# RENESAS TECHNICAL UPDATE

Product Category	MPU&MCU		Document No.	TN-H8*-A408A/E	Rev.	1.00
Title	Correction of errors in the H8SX/1663 Group Hardware Manual(2)		Information Category	Technical Notification		
Applicable Product	H8SX/1663 Group	Lot No.	Reference Document	H8SX/1663 Group Hardware Manual (REJ09B0294-0100)		
		All lots

(1) Page 396, DTCER description in figure 8.1, Block Diagram of DTC

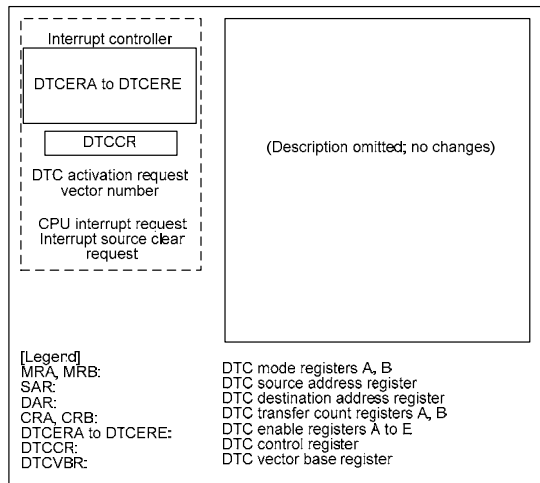
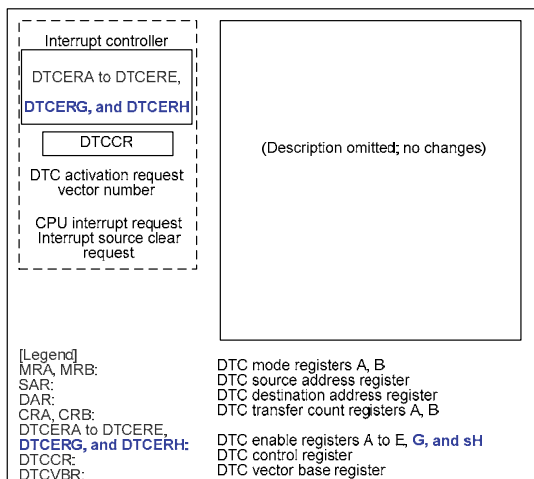
Deletion of DTCERG and DTCERH in DTCER
